Design Review Committee Meeting

February 17, 2021 6:00 PM

**DEPARTMENT OF PLANNING AND ZONING
PLANNER'S REPORT**

DATE: February 12, 2021
TO: Tonya Hutson
FROM: Lynn Patterson
RE: **Design Review – 3264 Springhaven/Stillwood Farm**

DATE:
12/13/2020
SCALE:
SHEET:
A0.1

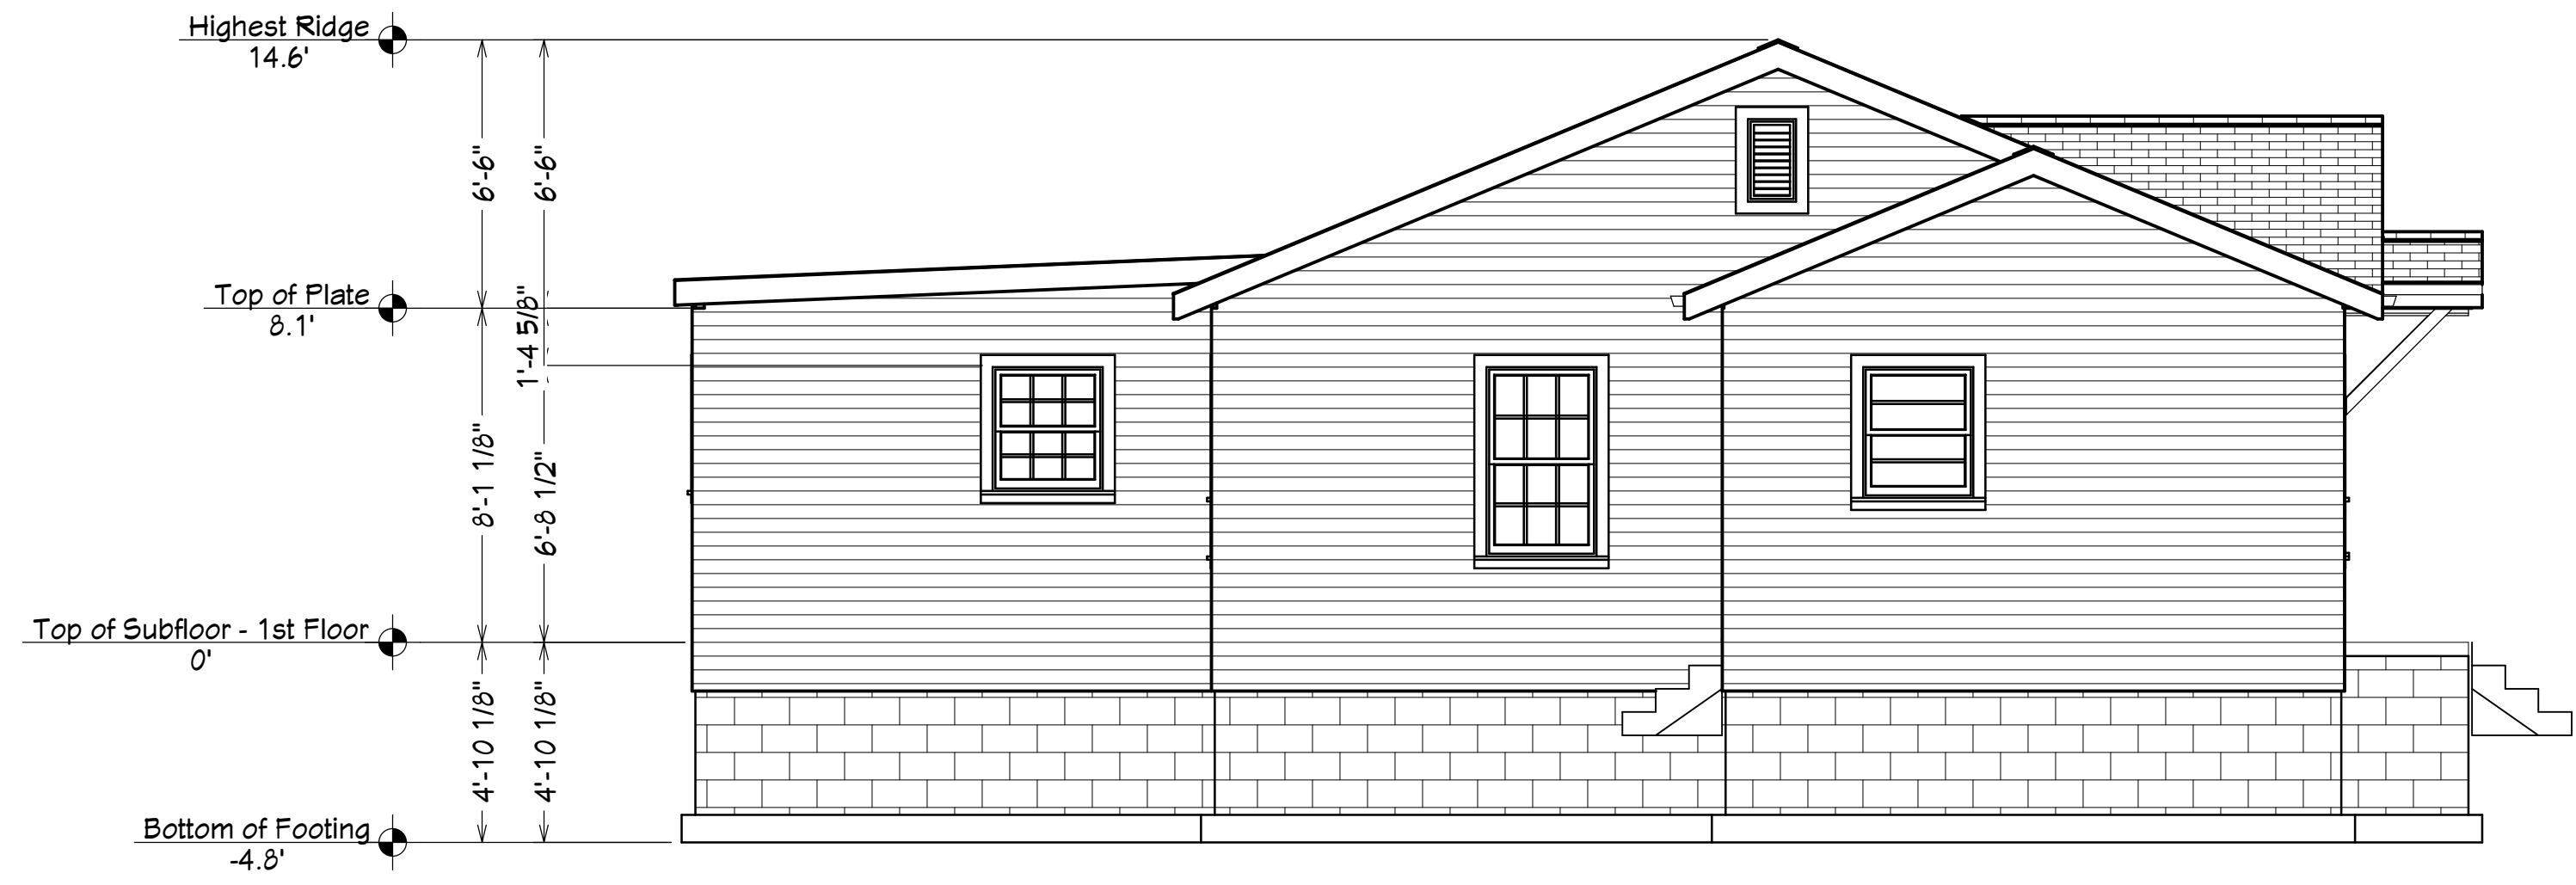
STAFF COMMENT: Existing sidewalk is shown on the plan.

STAFF COMMENT: Tree Conservation Plan to be finalized with Arborist. Street Tree required with final plan.

STAFF COMMENT: Driveway width is not provided. Driveway should be extended beyond supplemental area to accommodate 2 cars.

STAFF COMMENT: Provide walkway to sidewalk.

- Finalize Tree Conservation Plan and ensure street tree is included
- Height of first floor window sills.
- Walkway to sidewalk.
- Calculations to confirm window percentage of façade and also for wood trim/mullions.
- 30 year warranty for roof shingles
- Driveway width
- Extend driveway beyond supplemental area to accommodate 2 cars.
- Ensure mechanical is screened.

Land Lot 98
District 14
Fulton County, Ga.
Virginia Park
Lot 160
3358 Colville Ave.

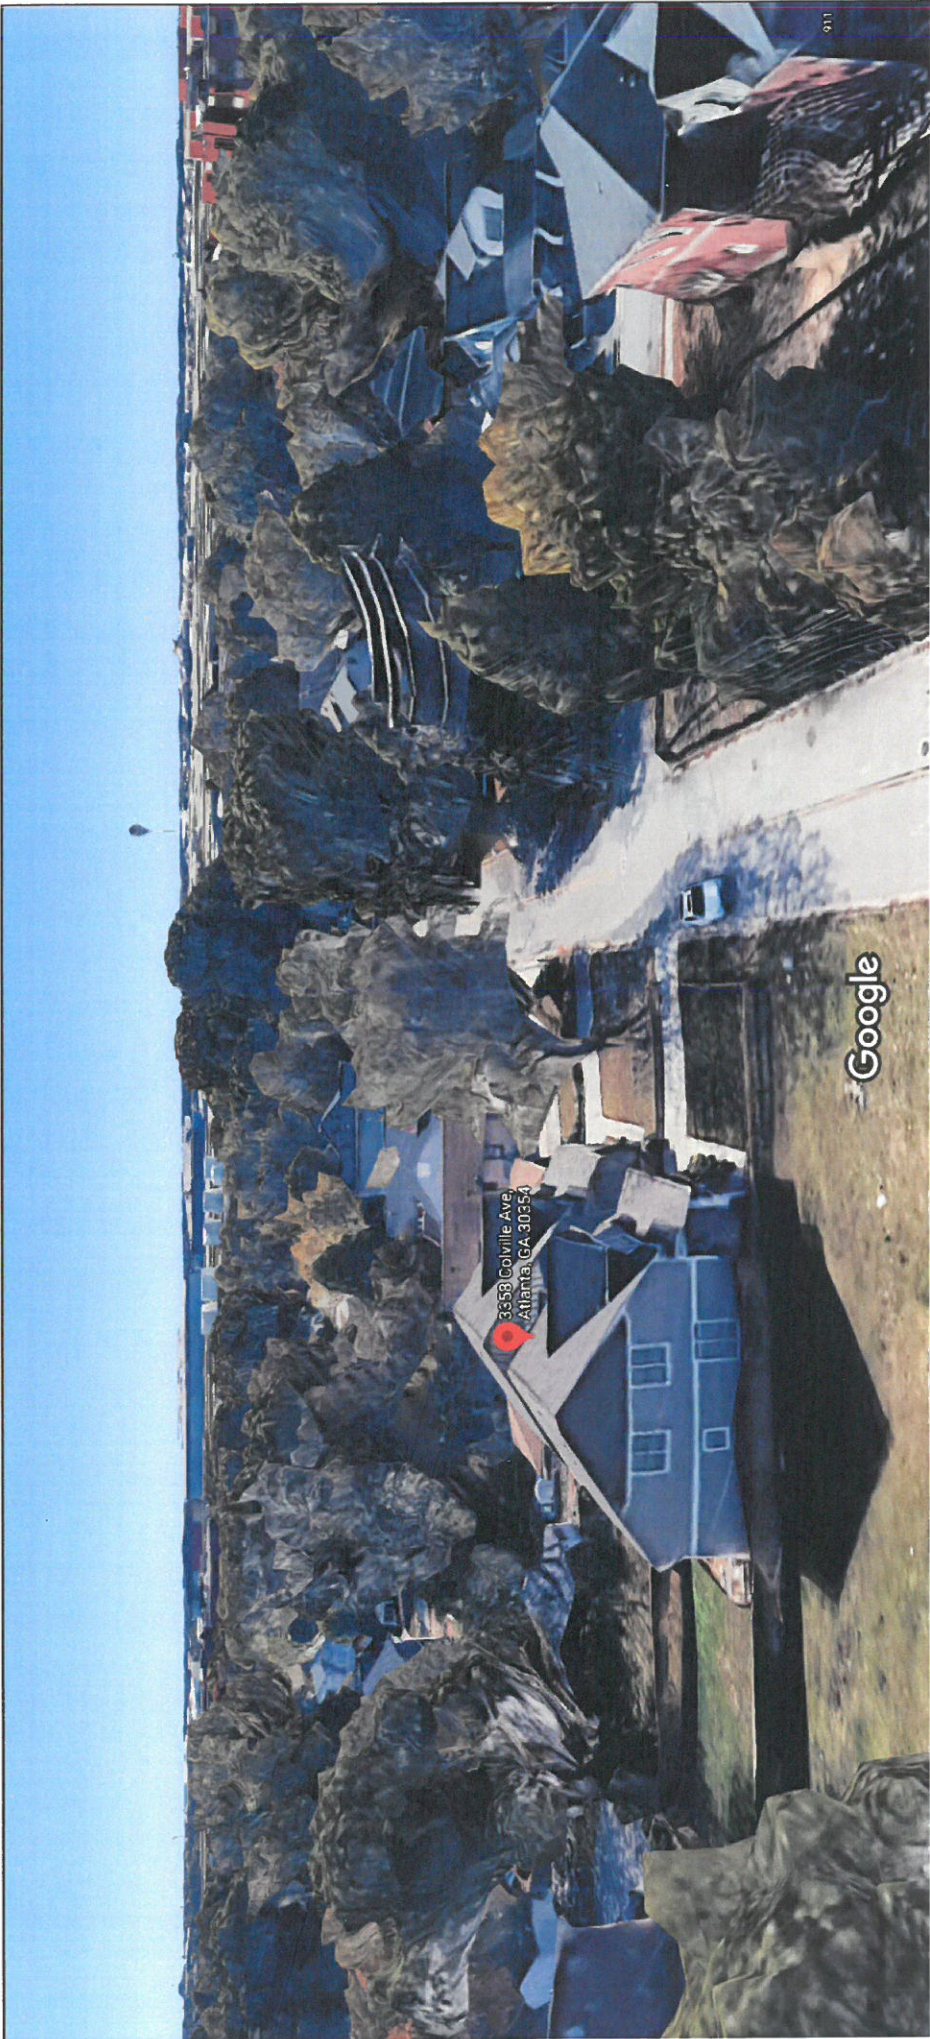
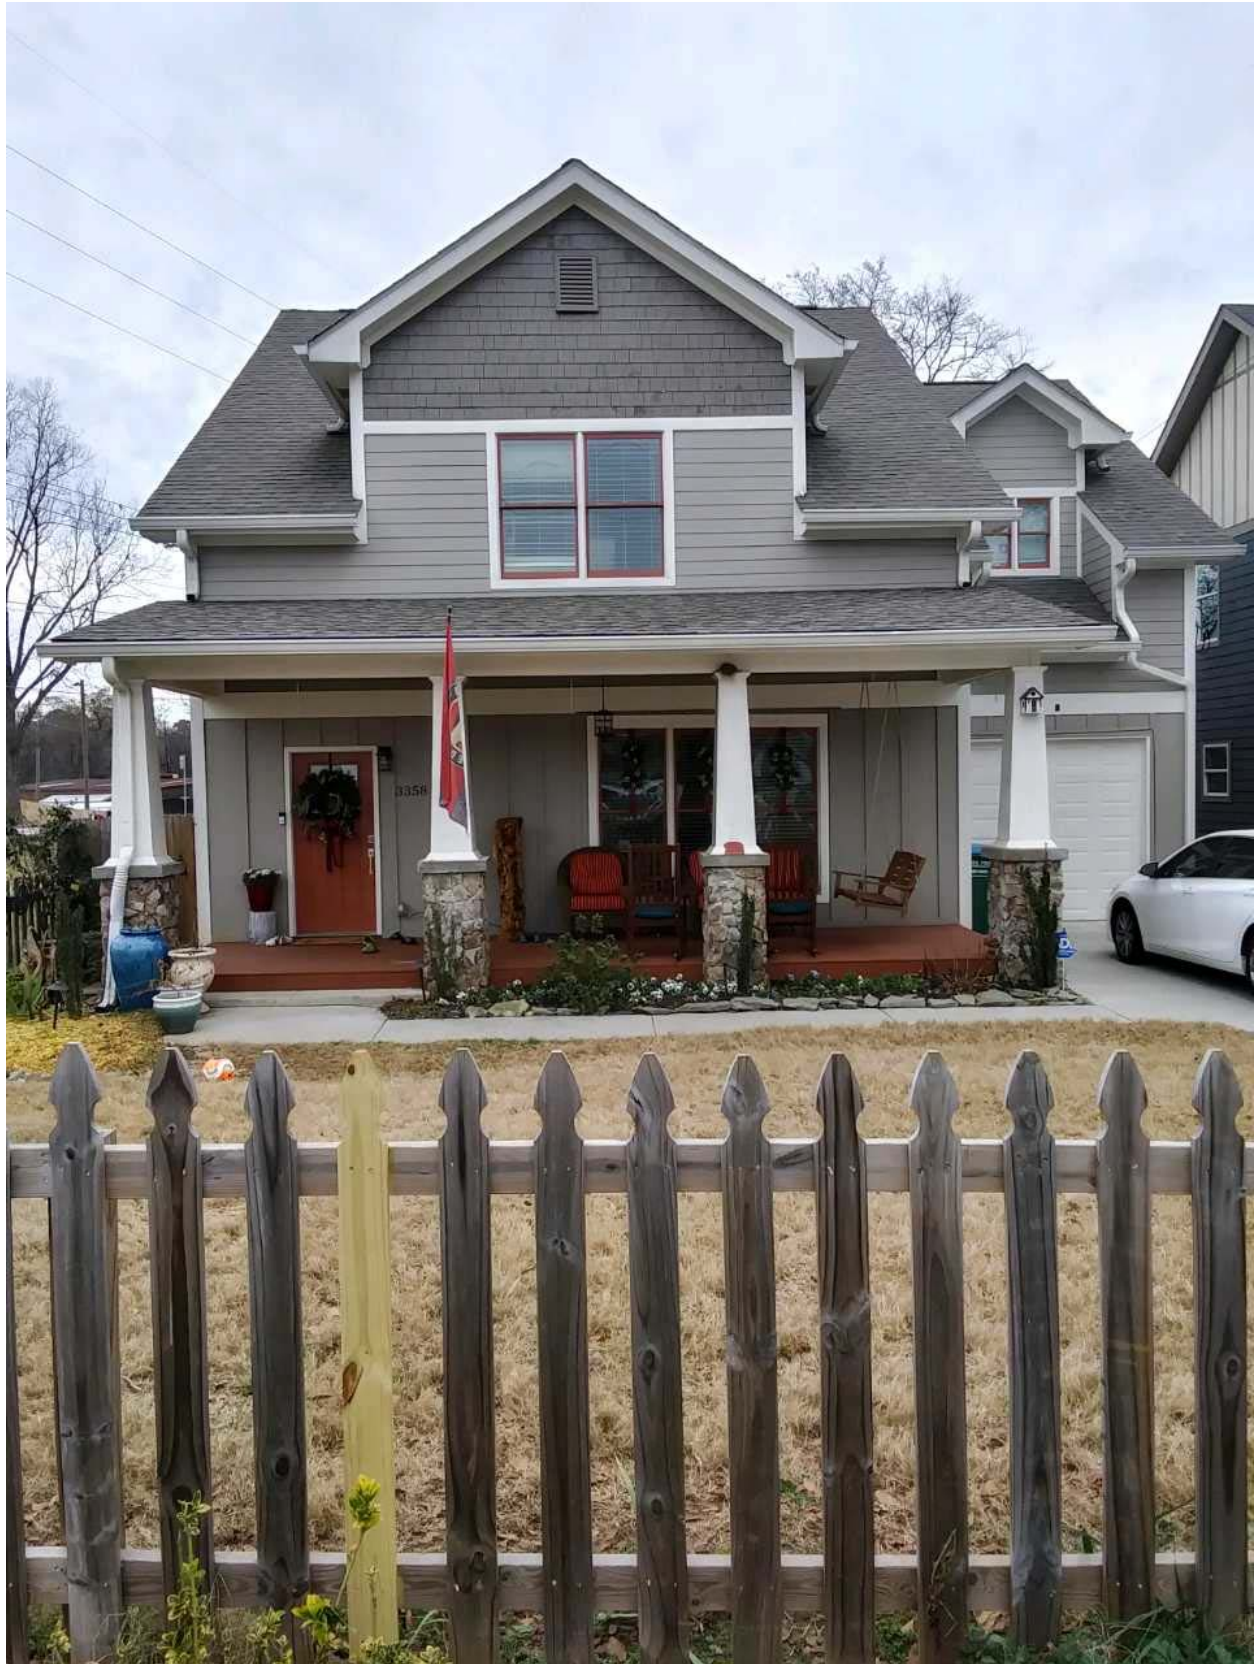
STAFF COMMENT: *There is no sidewalk. This is a small roof addition to the rear and outside the scope of the project..*

STAFF COMMENT: *Shingles must provide 30 year warranty. Gutters and downspouts not shown. Overhand is not provided. Aluminum posts are proposed.*

- *30 year warranty for roof shingles*
- *Show gutters and downspouts.*
- *Overhang of 12"*
- *Aluminum posts are proposed. DRC must render decision.*

Landscape and
Tree Conservation Plan
Phase 1
Tree removal
FOR

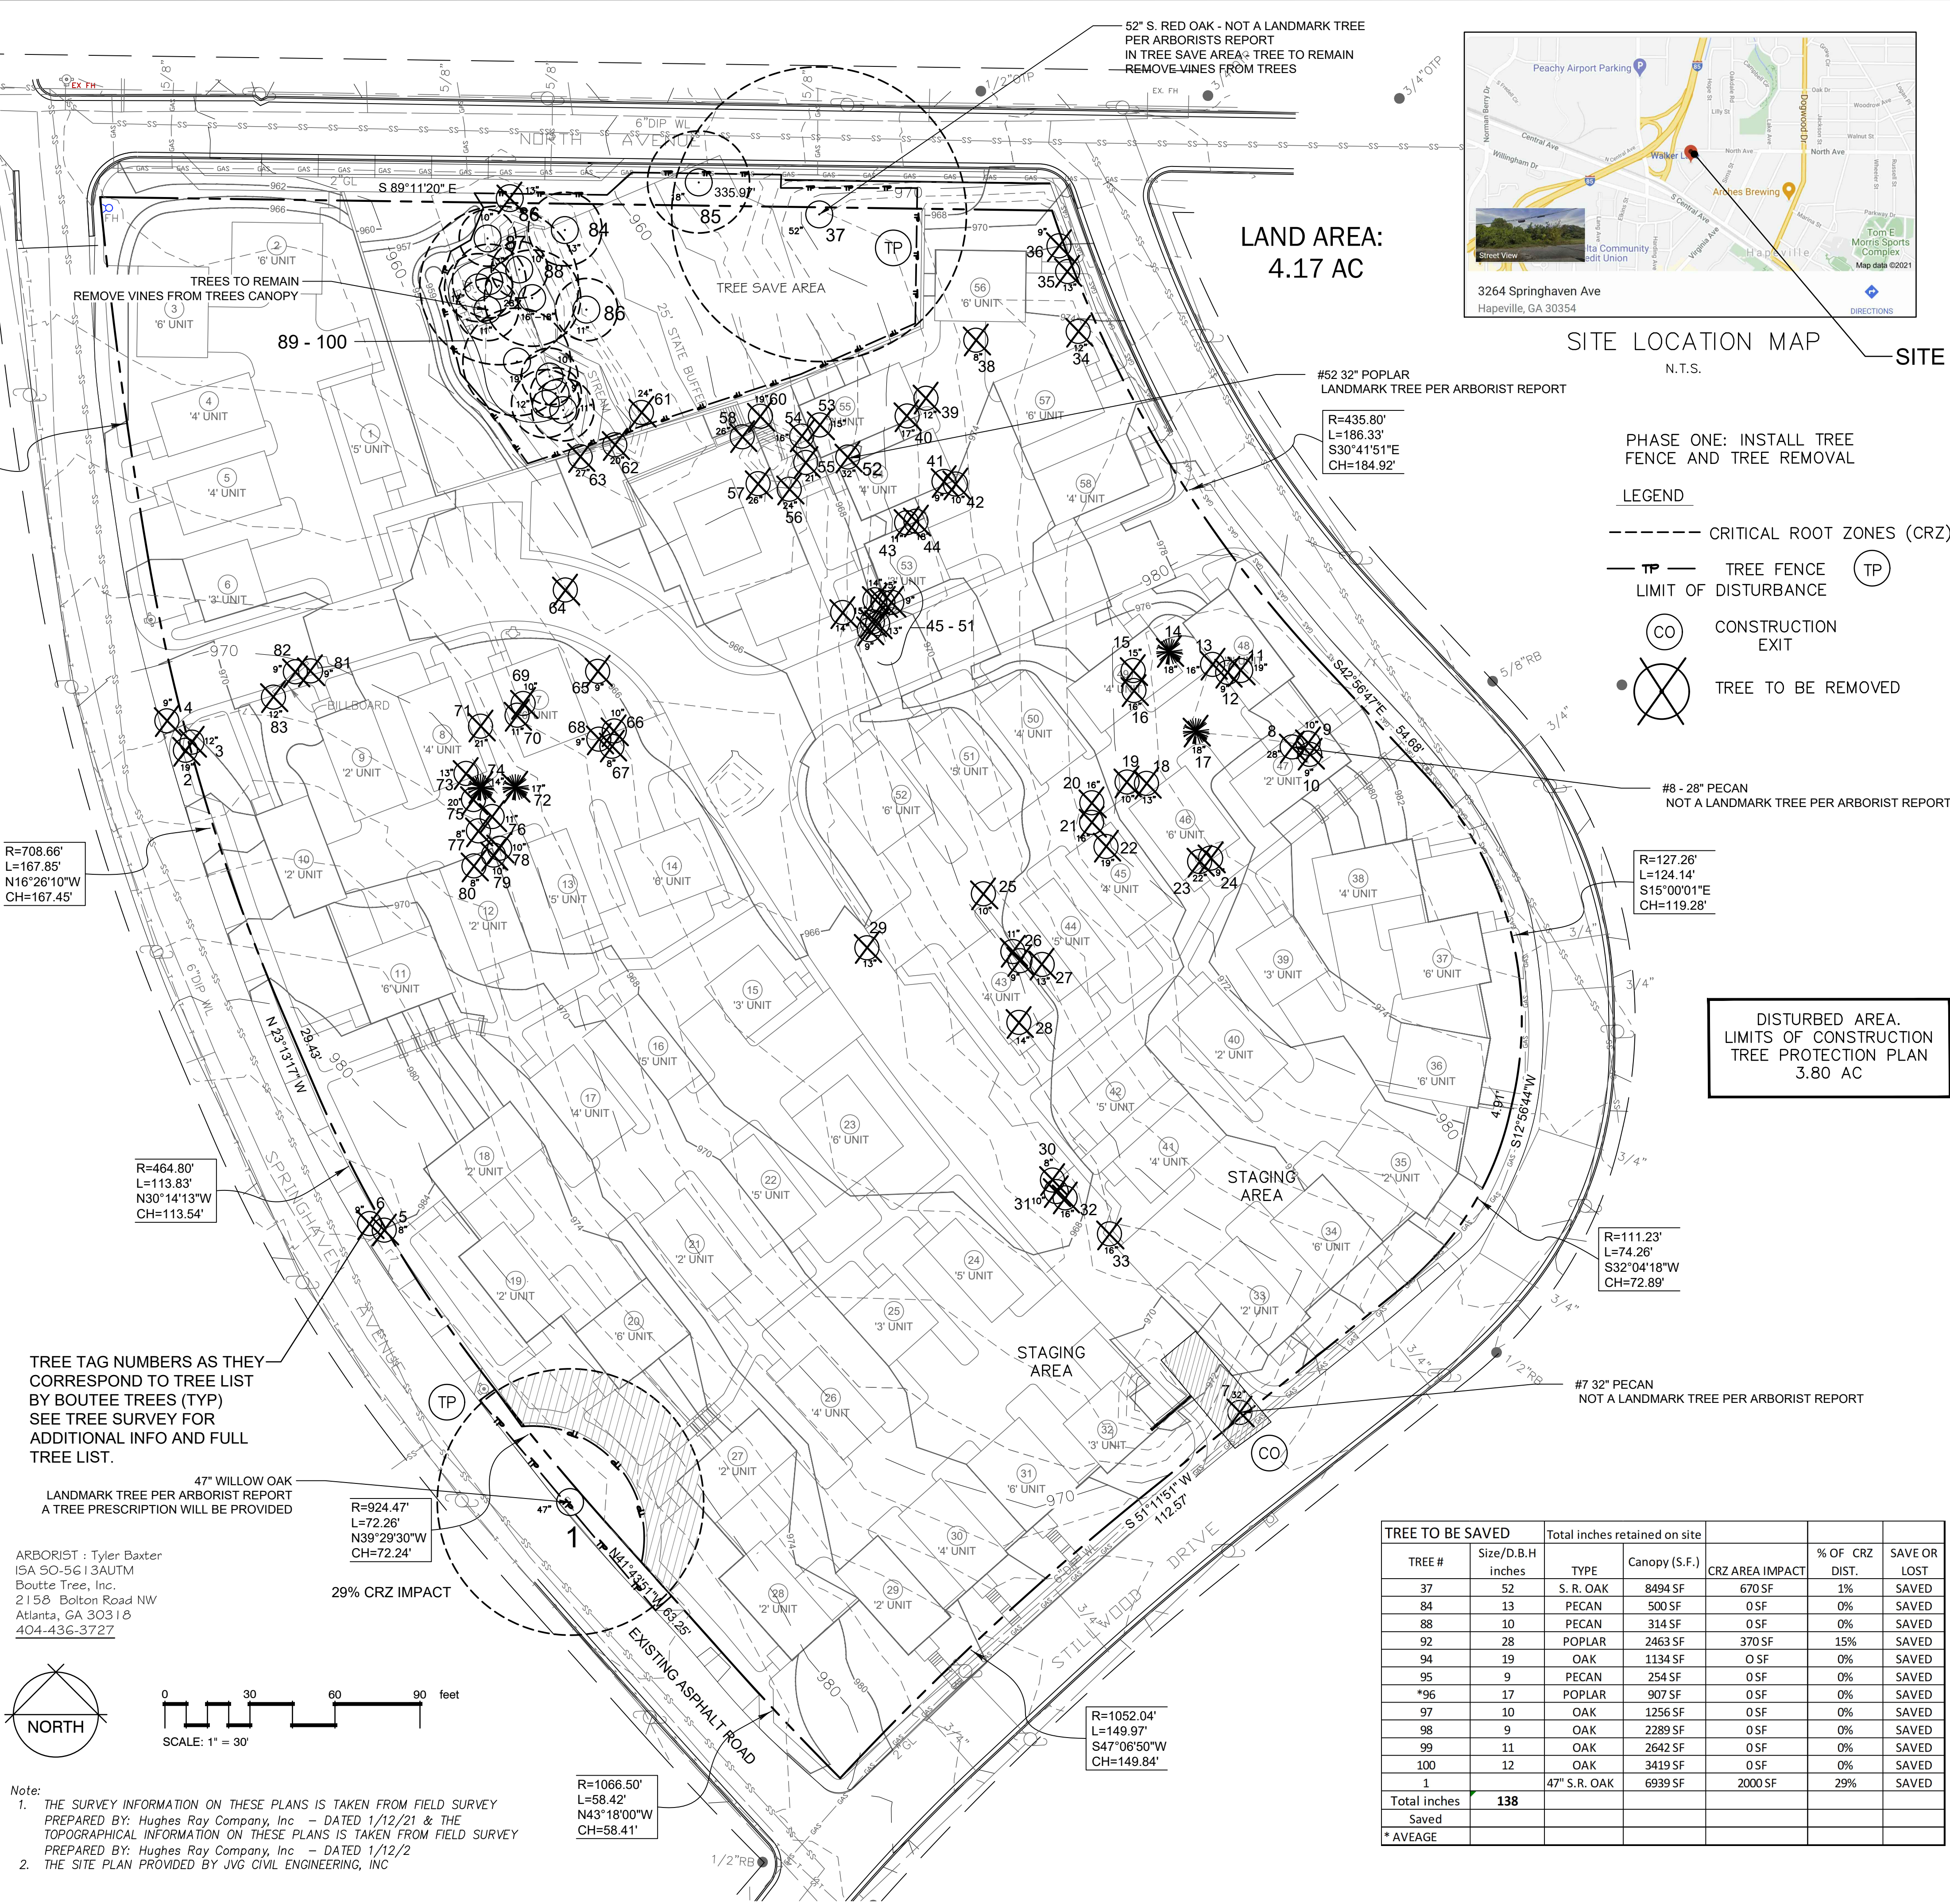
The City's arborist will review the final tree conservation plans. An initial review indicates the following corrections must be made. ANY impact to the CRZ does not allow for the tree to be counted as "SAVED". Three trees, 52" SR Oak, 28" Poplar and 47" SR Oak will have impacts in the CRZ and therefore must be removed from the calculation. Total saved inches therefore are 98 inches, not 138. Landmark trees in good health impacted must be recompensed either through replacement plantings or payment into the Tree Bank.
